# *Owosso Planning Commission*

RE: Special Planning Commission Meeting: February 2, 2016

# SITE PLAN FOR CARGILL ANIMAL NUTRITION PROJECT SPARTAN

**City of Owosso Planning Commission Staff Report**

**CHAIN LINK FENCE DETAIL**  
NOT TO SCALE

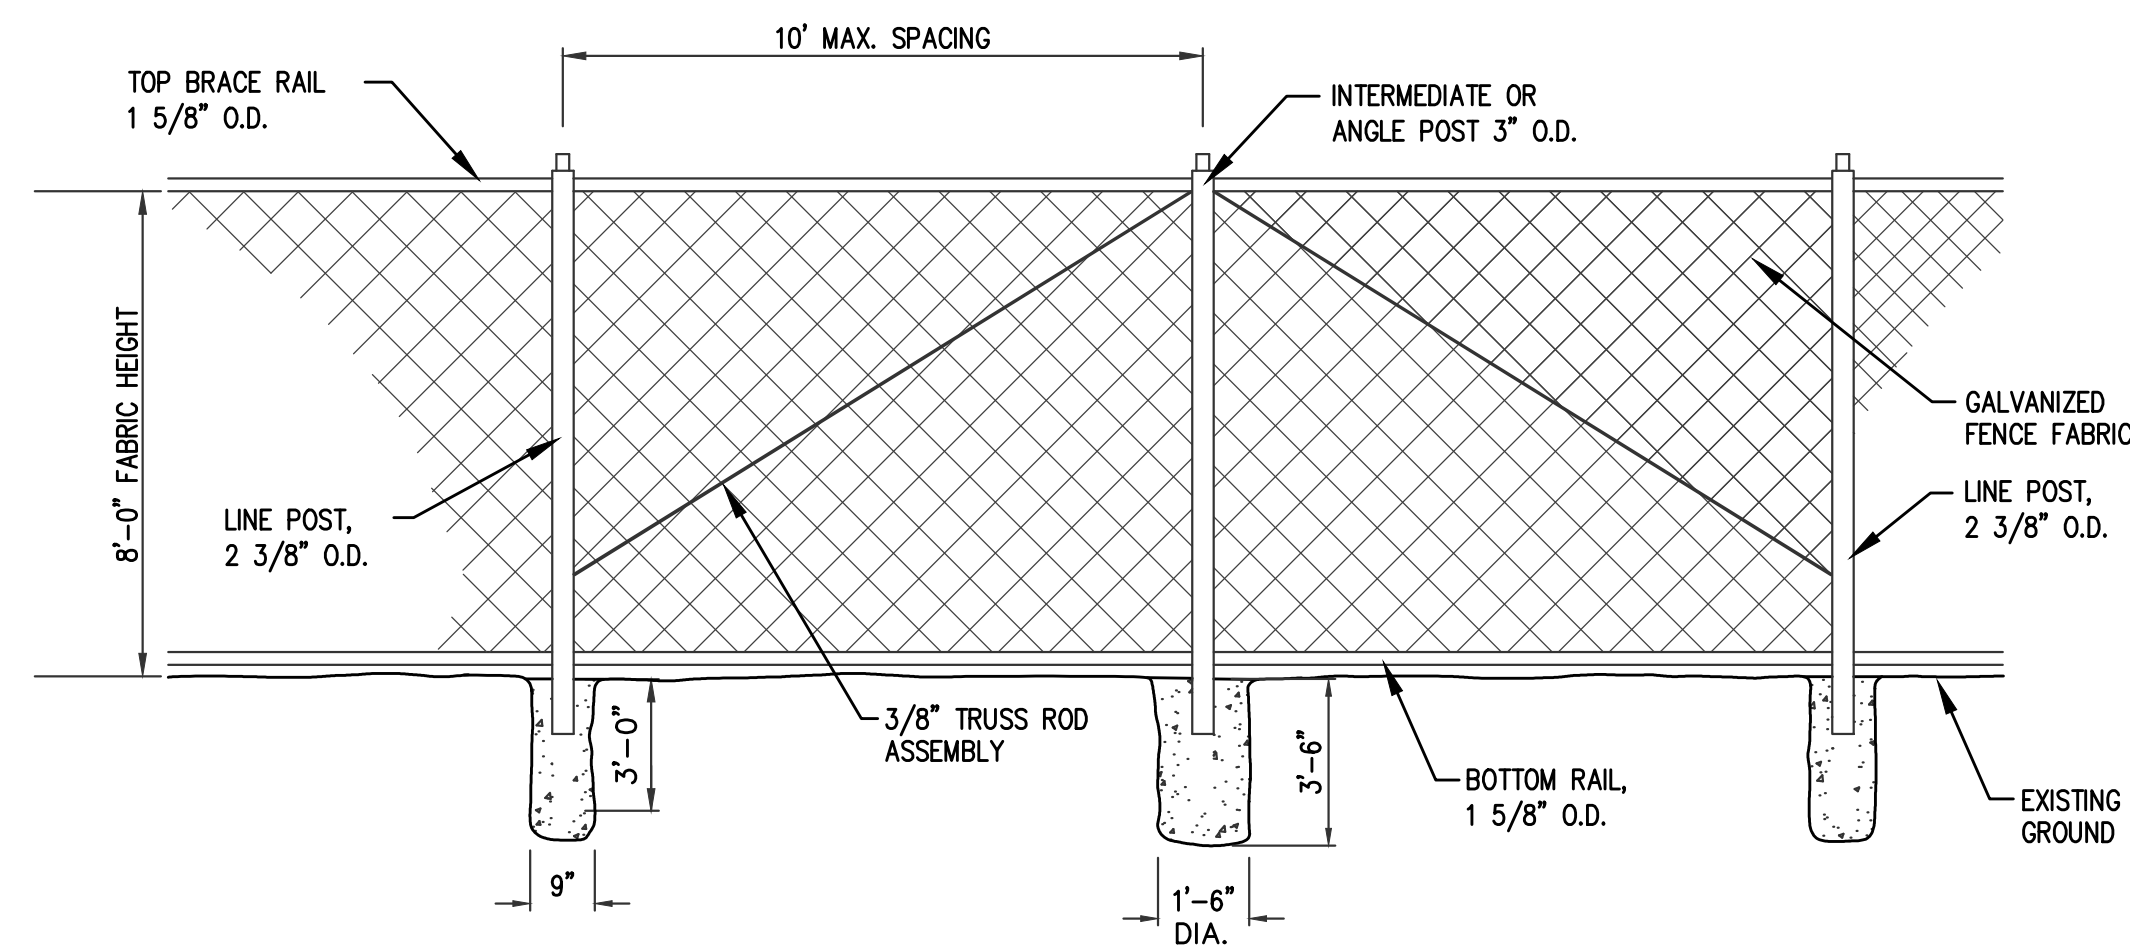
- c. All other notes on this page appear satisfactory.
2. Sheet C3, Legends, etc.
  - a. No Comment.
3. Sheet C4, Detail Sheet:
  - a. Chain-Link Fence: The Chain-Link detail shows a dimension of 3'-0" for the line post, from ground down to an area below the post. The depth of footing should be 3'-6" (minimum). All other dimension notes appear satisfactory.

**WATER VALVE AND BOX DETAIL**  
NOT TO SCALE

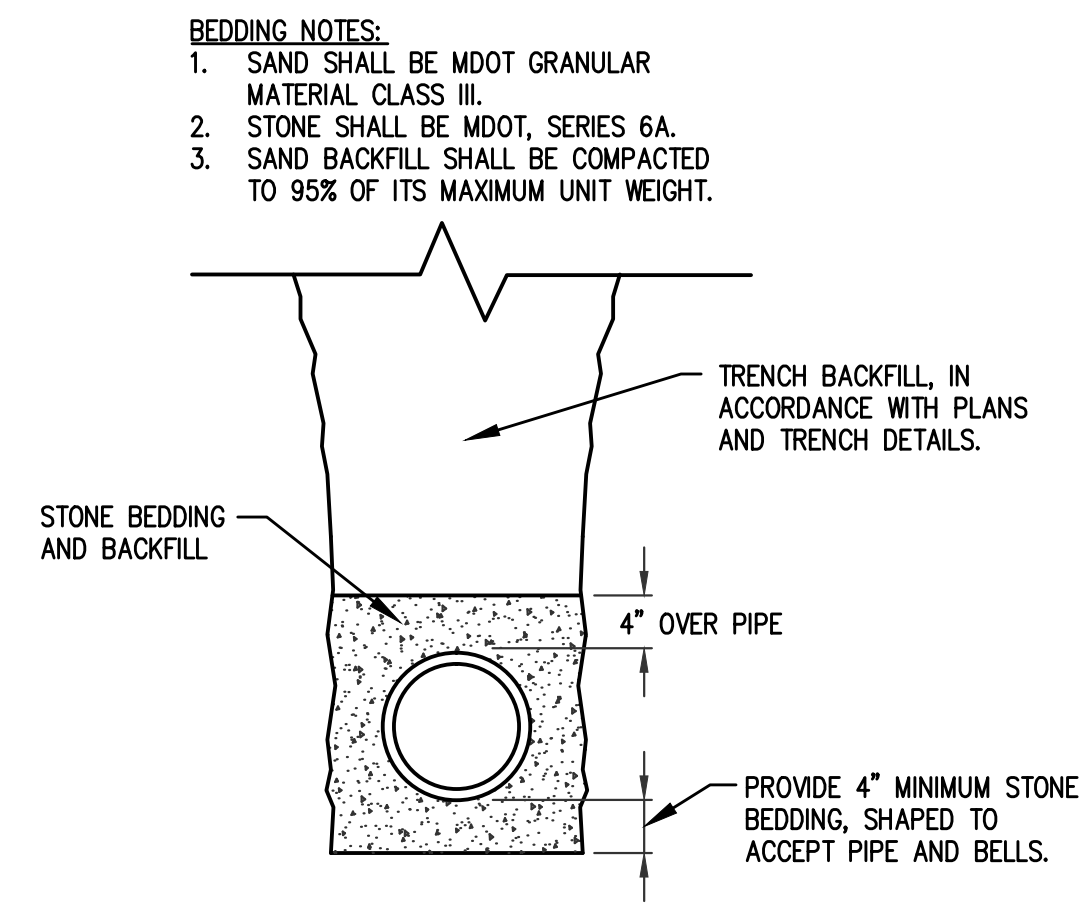
- b. All other notes and details on this page appear satisfactory.
4. Sheet C5, Detail Sheet:
  - a. Water Valve and Box: The Water Valve and Box detail calls for stone bedding under the valve. If the valve and box will be privately owned, then I recommend concrete blocking. If the valve and box will be city owned, then the detail must be changed to include concrete blocking.

- a) Water Valve & Box Detail. Valve boxes shall be Tyler 6860 series, three piece. Valve boxes shall be made of good quality cast iron and shall be of the sectional type. The lower section shall be a minimum of five inches in diameter, enlarged at the base to fit around the bonnet of the valve. The upper section shall be arranged to slide or screw down over the adjoining lower section and shall be full diameter throughout. Valve boxes shall be provided with cast iron lids or covers. Lids or covers shall be marked "WATER". The over-all length of valve boxes shall be sufficient to permit the top to be set flush with the final ground surface grade.

**STANDARD PIPE CULVERT DETAILS**  
NOT TO SCALE

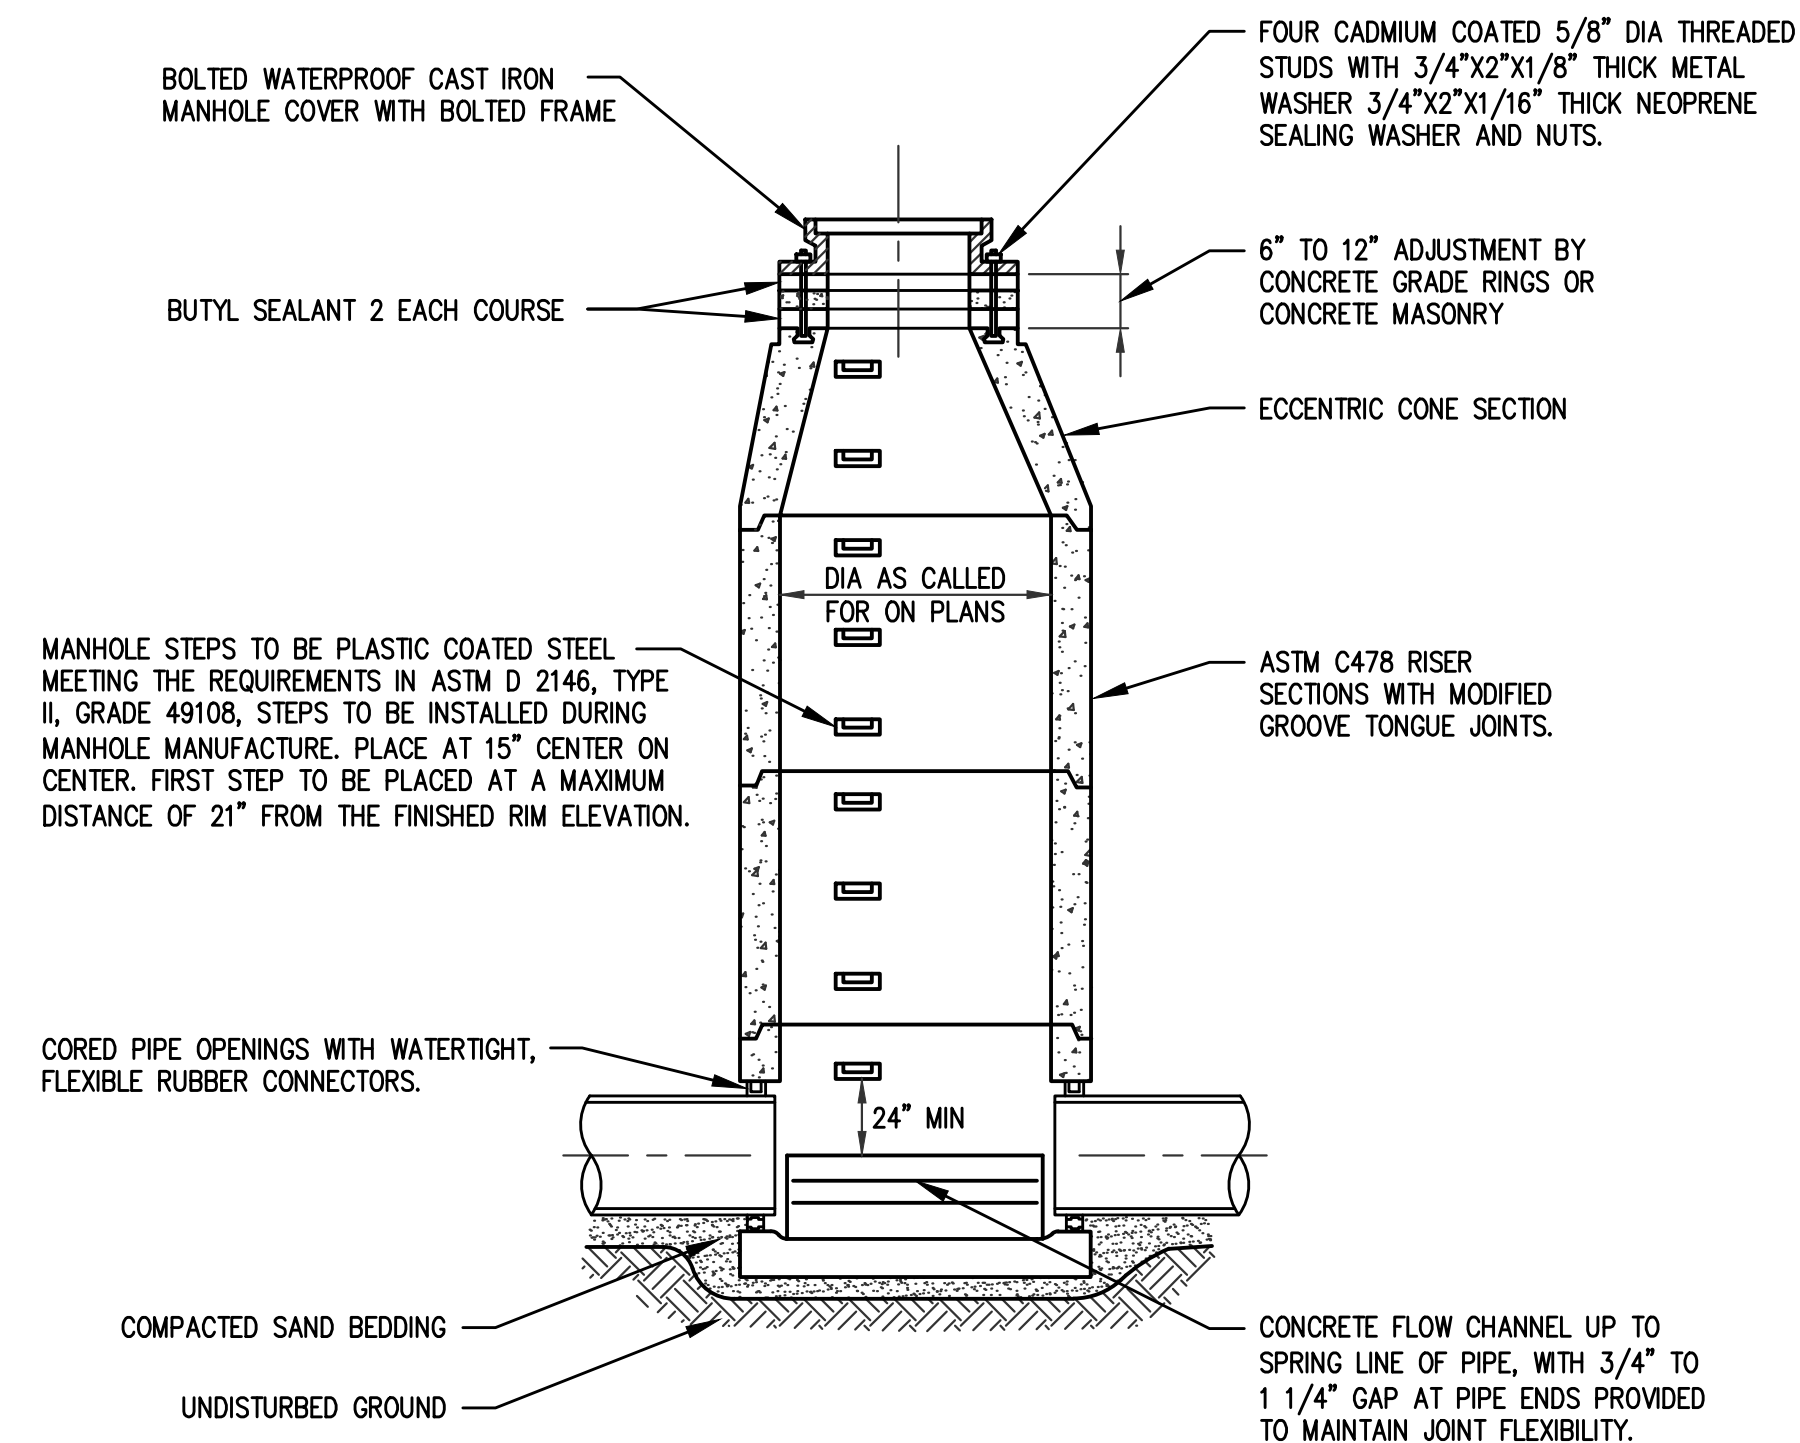
- c. Standard Pipe Culvert: The Standard Pipe Culvert Detail is satisfactory for all areas outside public right-of-way. Any plastic pipe culvert inside the public right-of-way must be SDR 26.

**STANDARD SANITARY MANHOLE**  
NOT TO SCALE

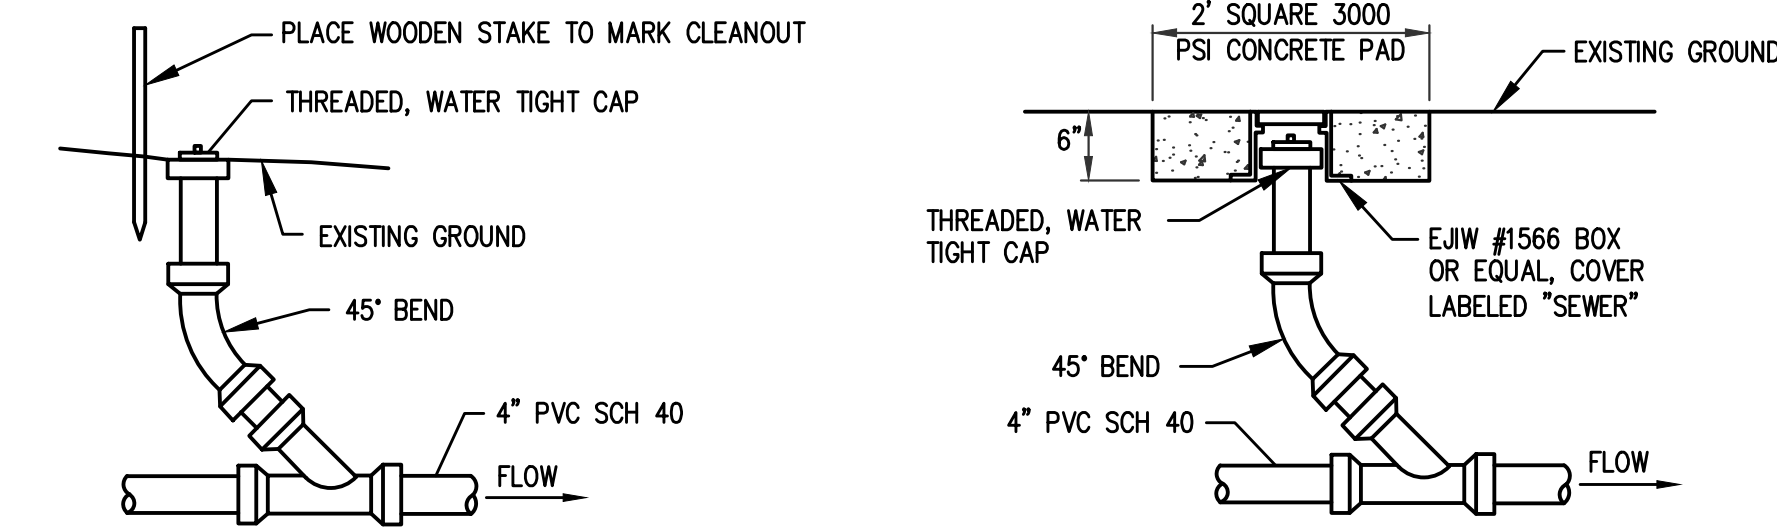
- b) Standard Sanitary Sewer Manhole.
  1. Precast Sections: (See attached Detail Sheet)
    - A. Integral Base - Manholes shall consist of integral cast base and riser sections conforming to ASTM C478.

**FOR PAVEMENT AREAS CLEANOUT RISER DETAIL**  
NOT TO SCALE

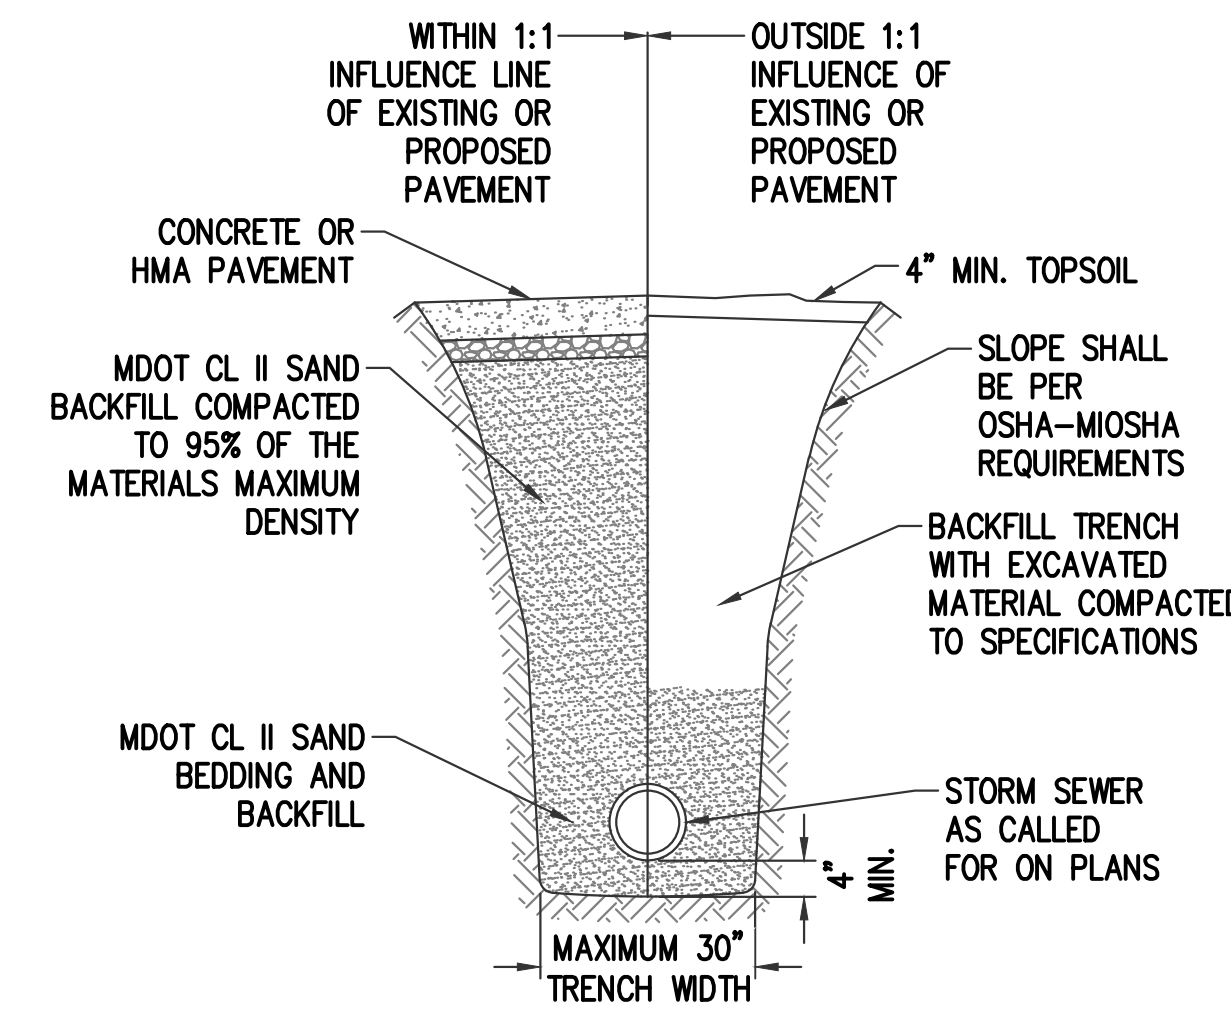
c) Cleanout Riser Detail: Prefer Detail as attached. Two (2 ft) square concrete pad for pavement areas is acceptable.
